LAND USE APPLICATION SUMMARY

Property Location: 1600 East 19th Street
Project Name: Anishinabe Bii Gii Wiin Parking Lot
Prepared By: Hilary Dvorak, Principal Planner, (612) 673-2639
Applicant: American Indian Community Development Corporation (AICDC)
Project Contact: Scott Nelson with DJR Architecture, Inc.
Request: To construct a new surface parking lot.
Required Applications:

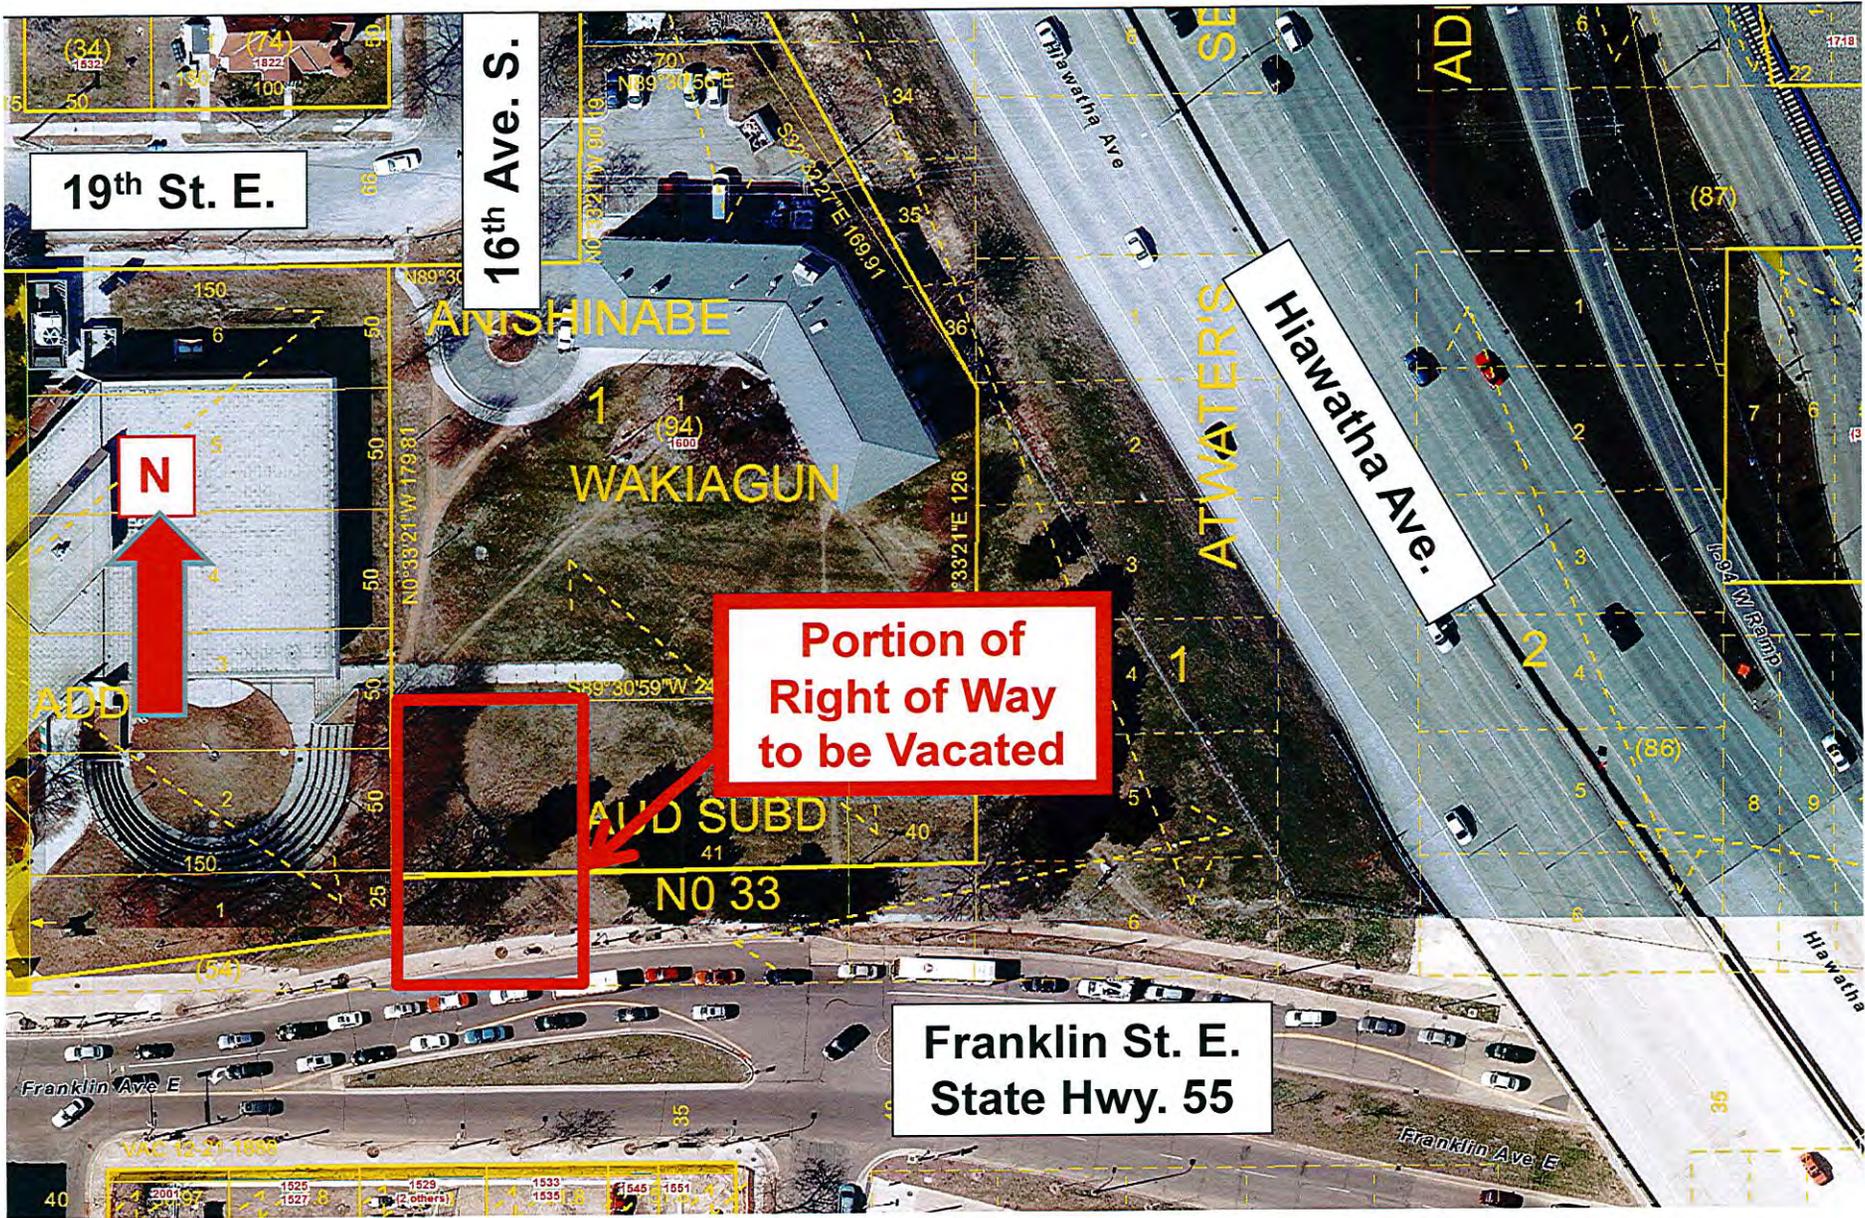
Comments: ACCORDING TO THE PLANS, THERE WILL BE NARROWING OF FRANKLIN AVE TO LESS THAN 20 FEET. MN STATE FIRE CODE REQUIRES THAT MINIMUM DISTANCE FOR EMERGENCY VEHICLES.

LANDSCAPE PLAN

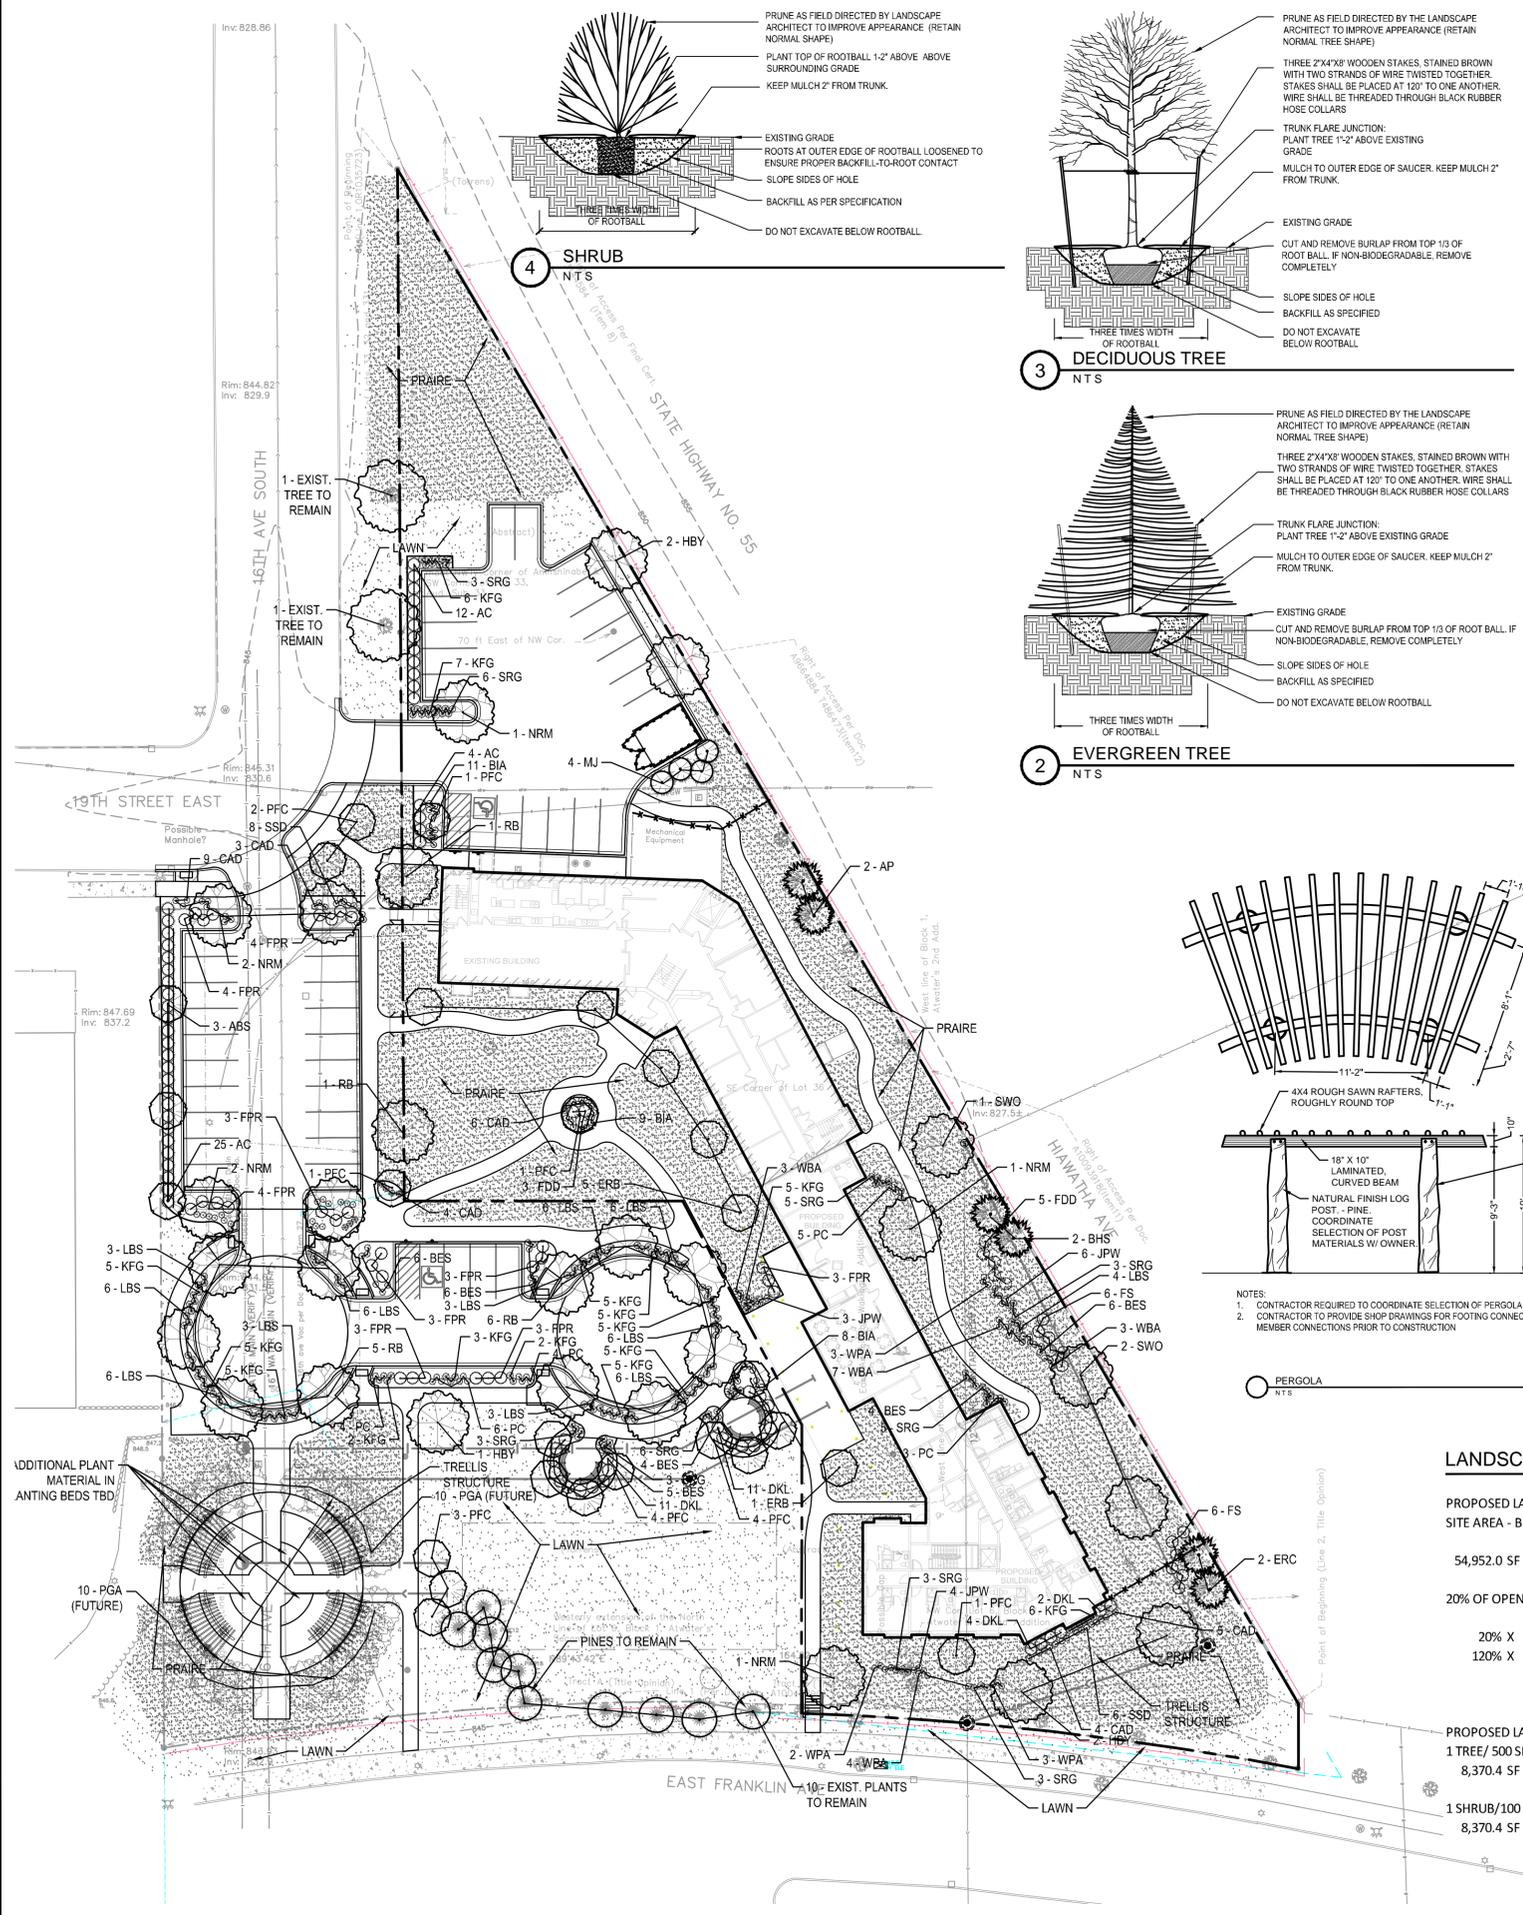
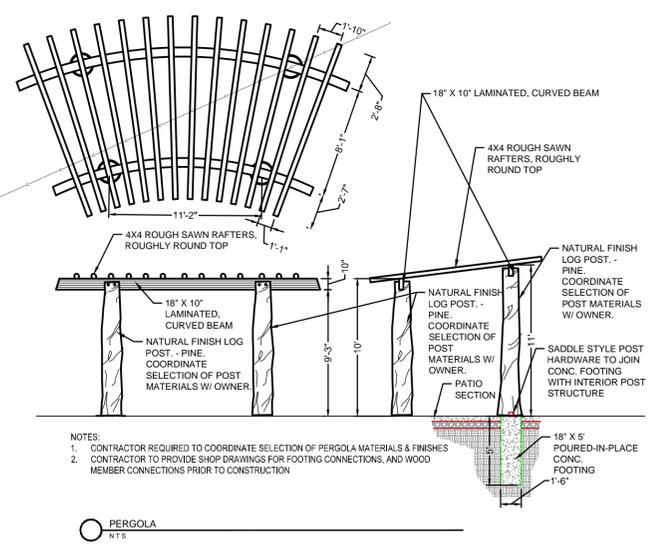
- The zoning code requires at least 1 canopy tree for each 500 square feet of required green space and at least 1 shrub for each 100 square feet of required green space be planted on the site. The tree and shrub requirement for this site is 17 and 83 respectively. The applicant is providing a total of 37 canopy trees and 71 shrubs on the site. In addition, the applicant is proposing to provide a total of 17 ornamental trees and 164 perennials, grasses and ground cover on the site. CPED is recommending that the required number of shrubs be provided on the site.

1. Approval of the final site plan, landscaping plan, elevations and lighting plan by the Department of Community Planning and Economic Development.
2. All site improvements shall be completed by July 24, 2017, unless extended by the Zoning Administrator, or the permit may be revoked for non-compliance.
3. The required number of shrubs shall be provided on the site.
